**CERTIFICATE OF APPROPRIATENESS**

**Property:** 2609 Stanford St, lot 11, tracts 3B & 4B, block 3, Montrose Subdivision. The property includes a historic 1,891 square foot, one-story wood frame single-family residence and a detached garage situated on a 5,500 square foot (55' x 100') interior lot.

**Proposal:** Alteration – Remove a casement window and wood and glass door from the north (side) elevation and shorten the openings to install wood-clad single-pane windows to match single-pane windows existing on the structure.

**NORTH SIDE ELEVATION**  
EXISTING DOOR AND WINDOW

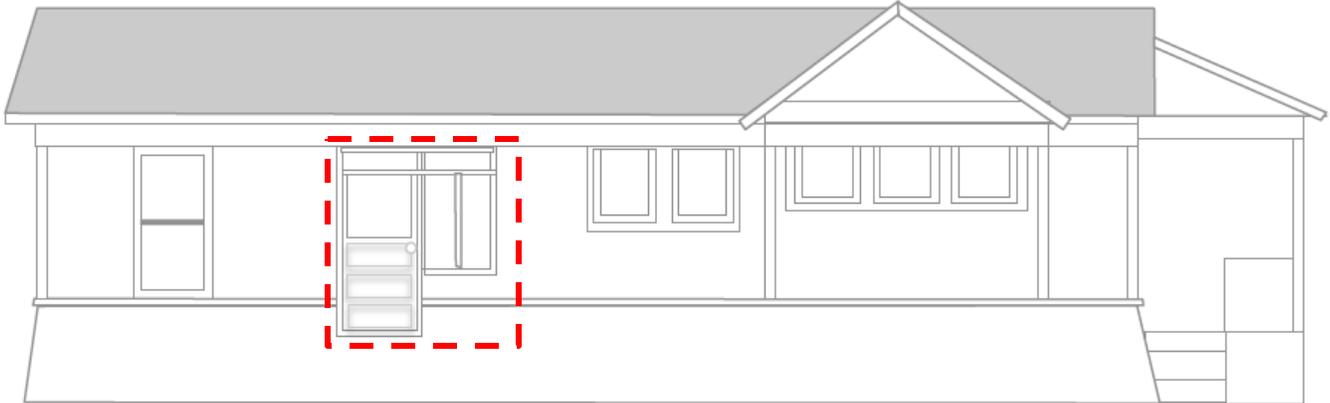
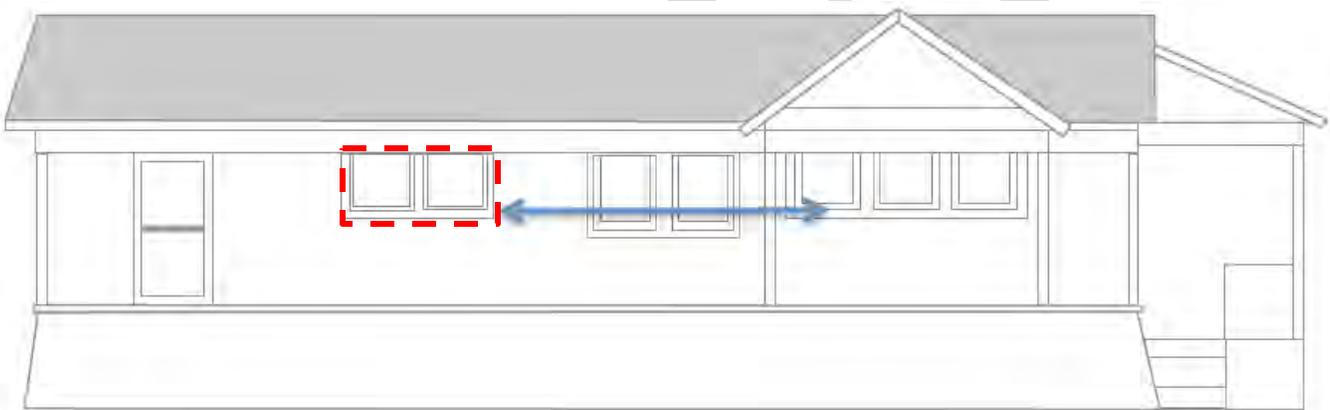
**Side Elevation:** The elevation contains three single-pane square windows, three 1-over-1 windows, a casement window and a wood with glass-lite door. The door and casement window opening measures 65" wide total, the door measuring 32" wide by 81" tall and the window measuring 27" wide. There is approximately 6" of trim. The alteration removes the door and casement window and replaces them with two, single-pane, wood-clad, 27" tall windows to match the existing opening width at 65". The remainder of the openings will be filled in with salvaged 117 and lap siding.

**Recommendation:** Approval

**NORTH SIDE ELEVATION**  
REMOVE EXISTING STOVE FLU

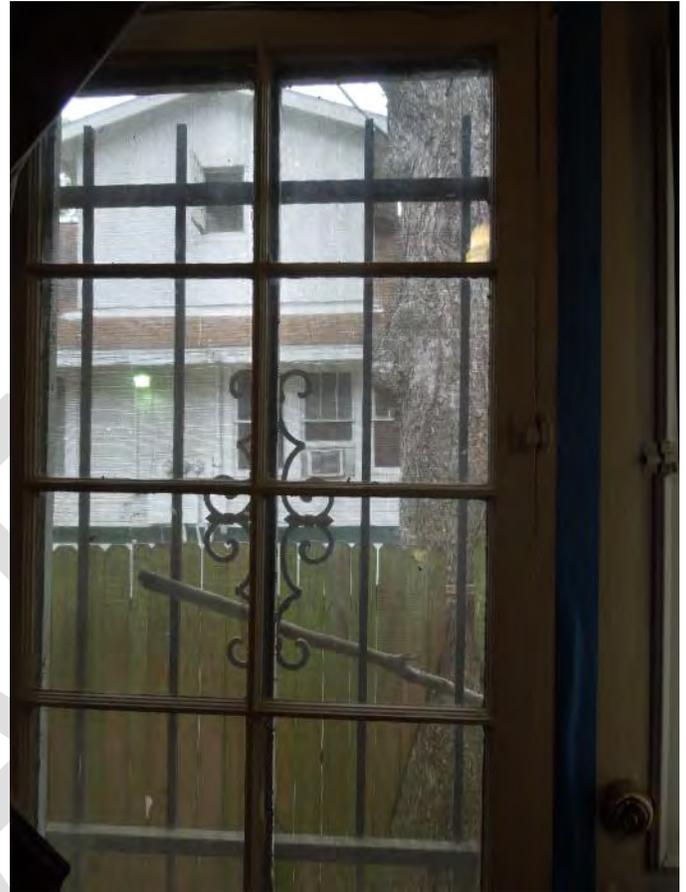
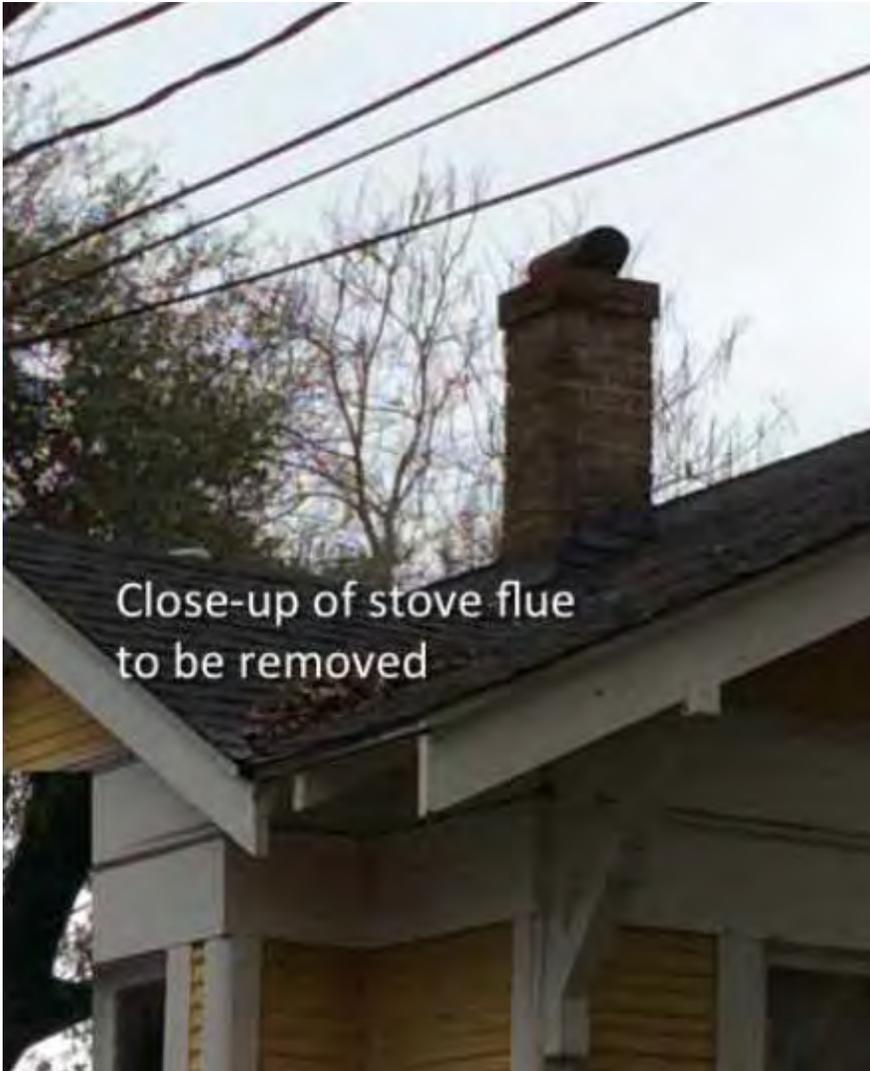
- Infill the remaining openings with salvaged 117 and lap siding from the structure.
- Remove a brick stove flu from the north (side) of the residence and patch over the opening with new roof materials to match.

**Roof:** The brick stove flu will be removed and the roof patched to match the existing roof.
